Subject: Chula Vista Energy Upgrade Project (07-AFC-4)  
Data Request Response to CEC Staff Data Requests 1 through 47 and Workshop  
Query 1

Application for Certification  
For the **CHULA VISTA ENERGY  
UPGRADE PROJECT**

**Response to CEC Staff Data Requests  
1 through 47 and Workshop Query 1**

USGS 15 Minute Series Topographic Map  
San Diego Quadrangle

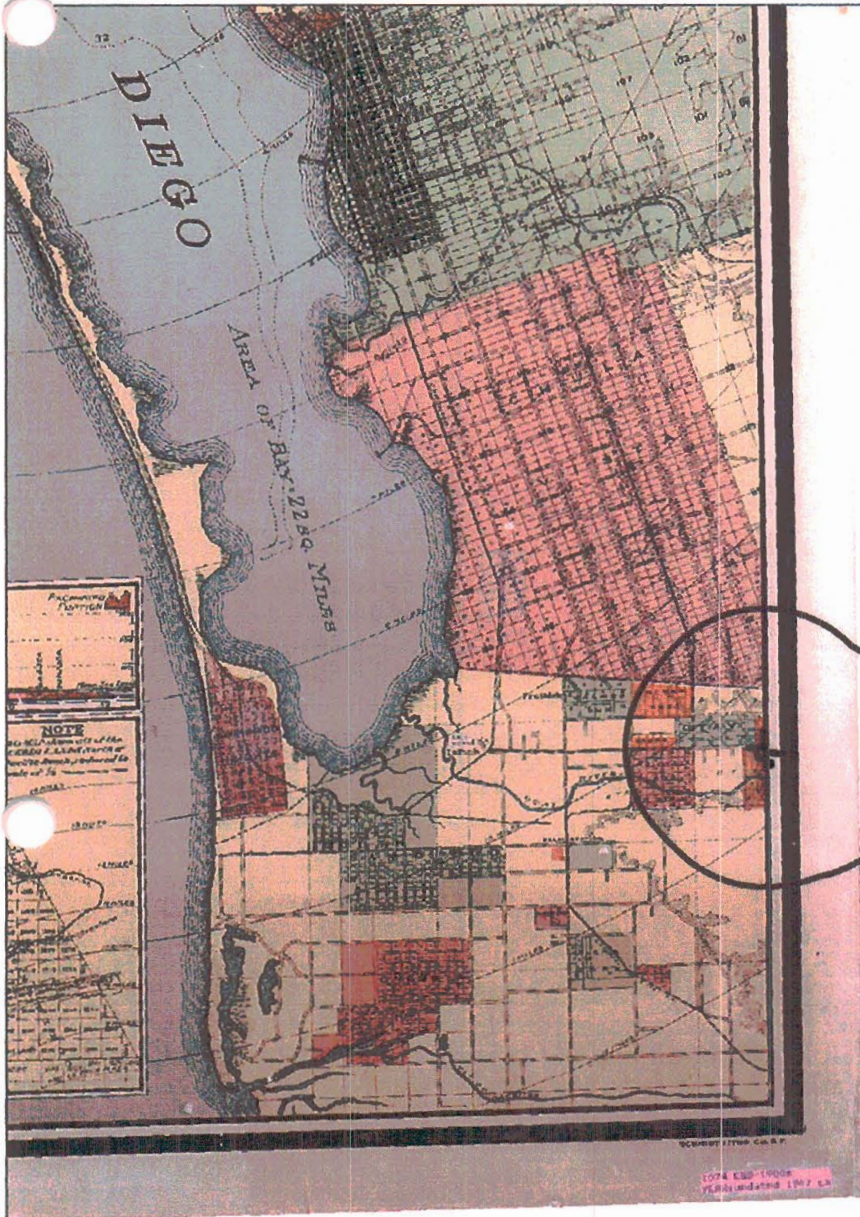
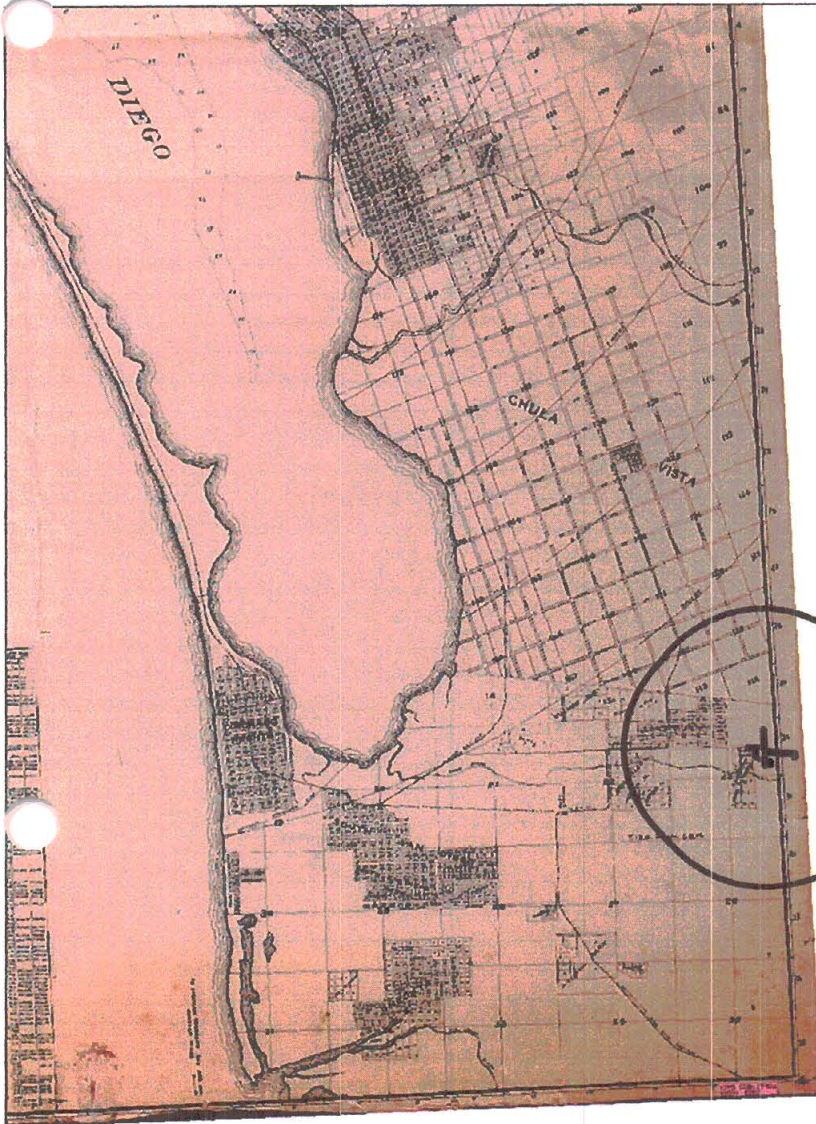
37. *Please provide copies of any historic maps received from the CHRIS that were not included in the previously submitted confidential filing.*

**Response:** Historical maps provided by the CHRIS are attached as Attachment DR37-1.

**FIGURE 1**  
**AMMONIA CONCENTRATIONS**  
**CATASTROPHIC RELEASE SCENARIO**  
 CHULA VISTA ENERGY UPGRADE PROJECT  
 CHULA VISTA, CALIFORNIA

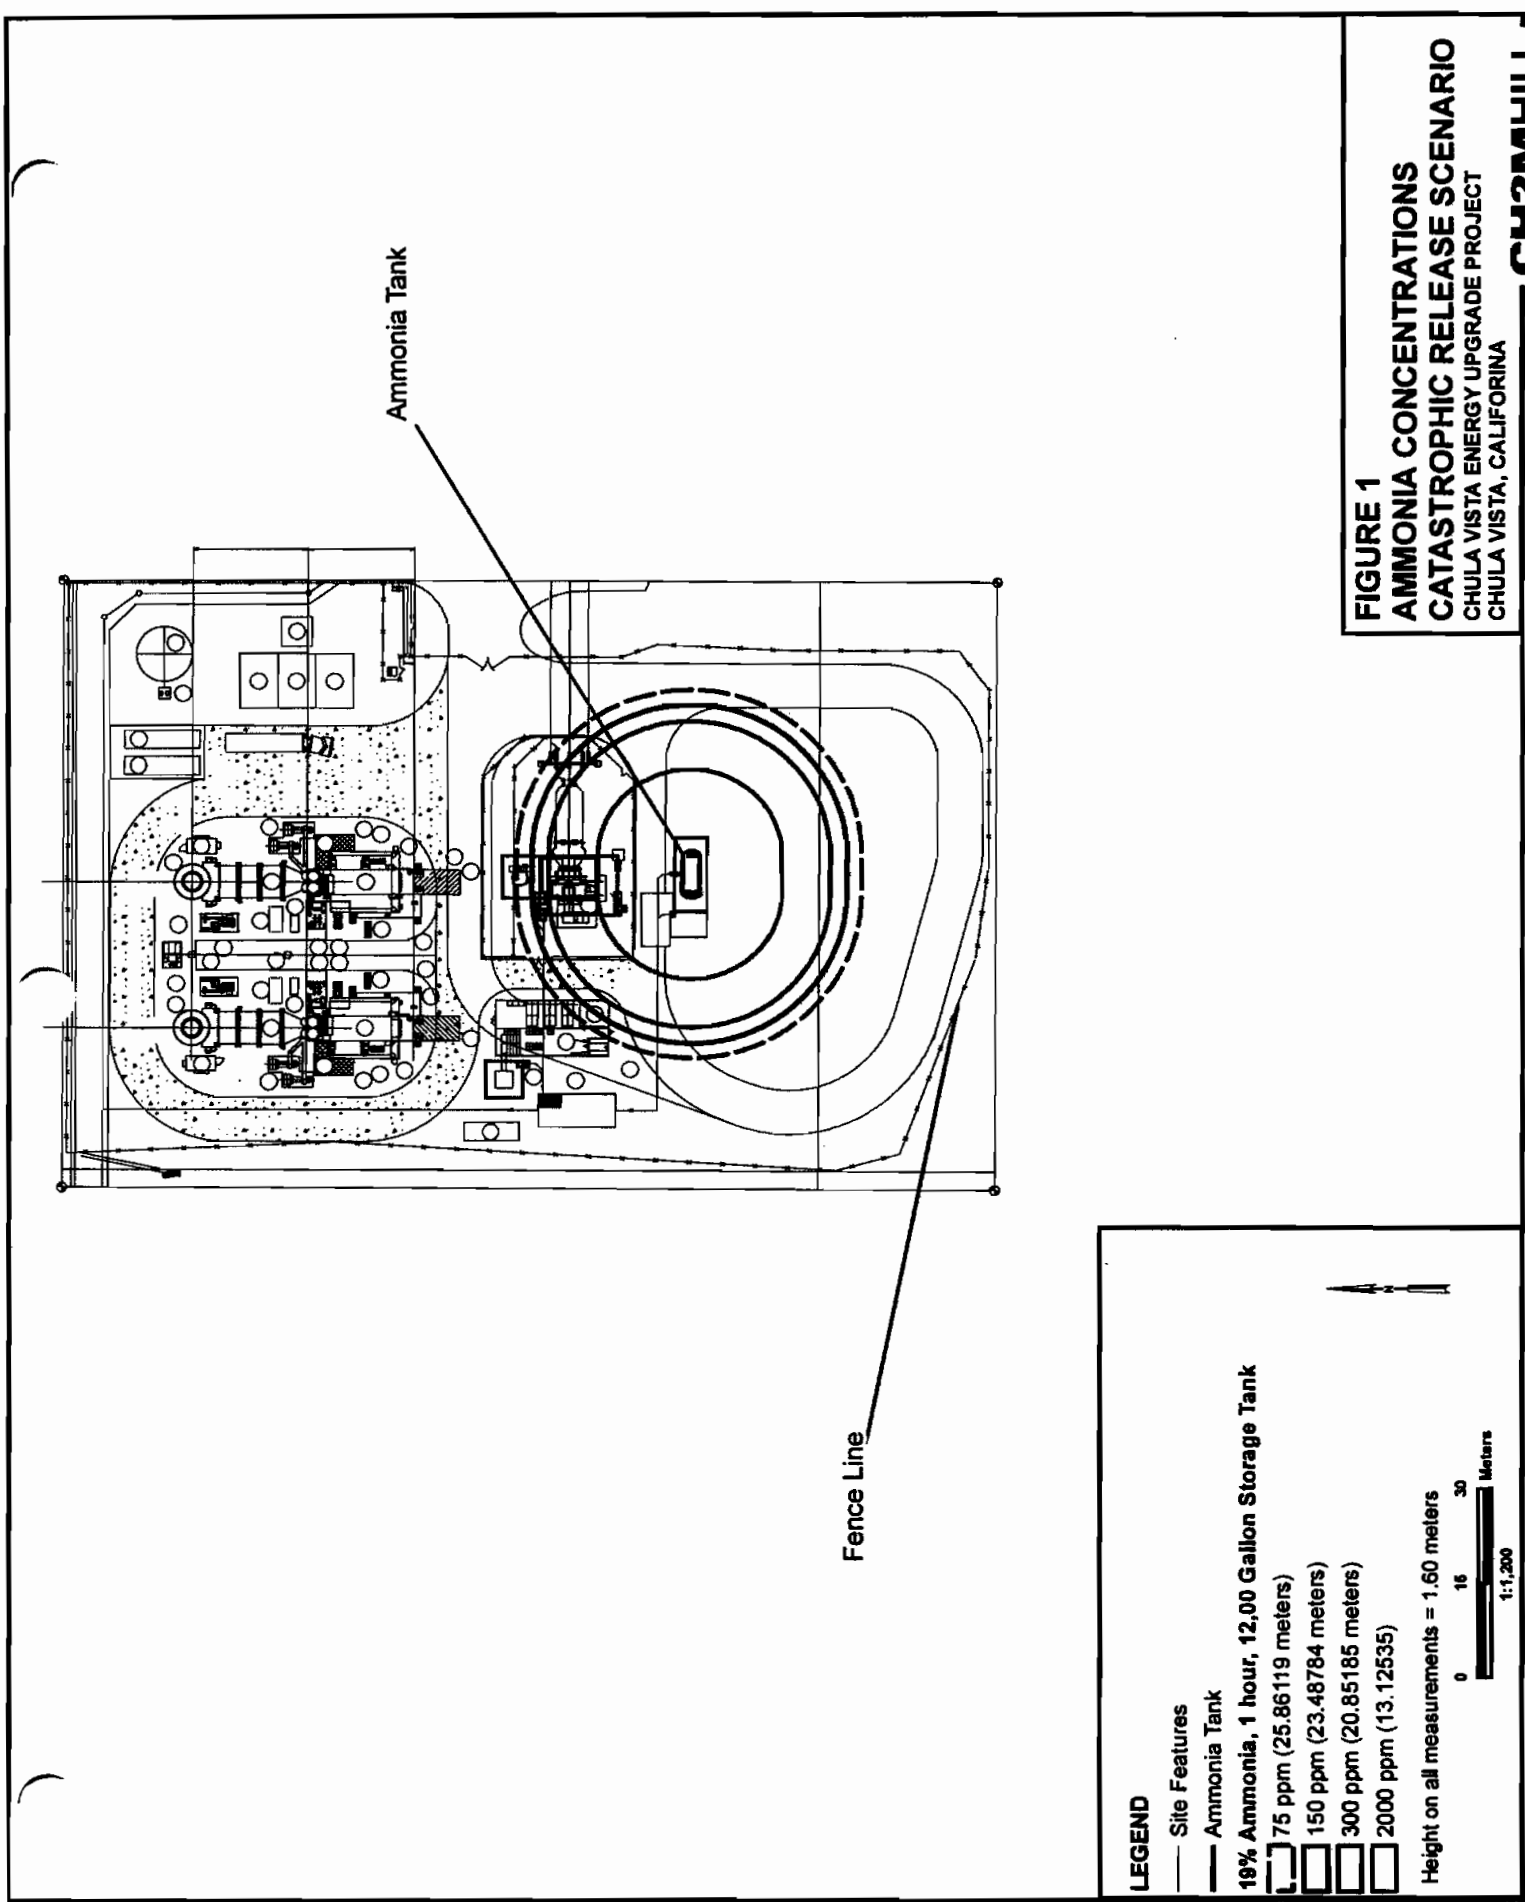
*WSQ-1 Please provide a modeling analysis of the off-site consequences of a catastrophic release of ammonia (a) from the CVEUP's on-site ammonia storage tank, and (b) during the ammonia tank loading.*

The results of the off-site consequence analysis for the worst case release scenario of ammonia at CVEUP indicate that the concentrations above the most stringent benchmark criteria (CEC's significance value of 75 ppm) would not extend off the project site. Results of the alternative case indicate that only the CEC's significance criteria of 75 ppm would extend off the project site (see Figure 1).
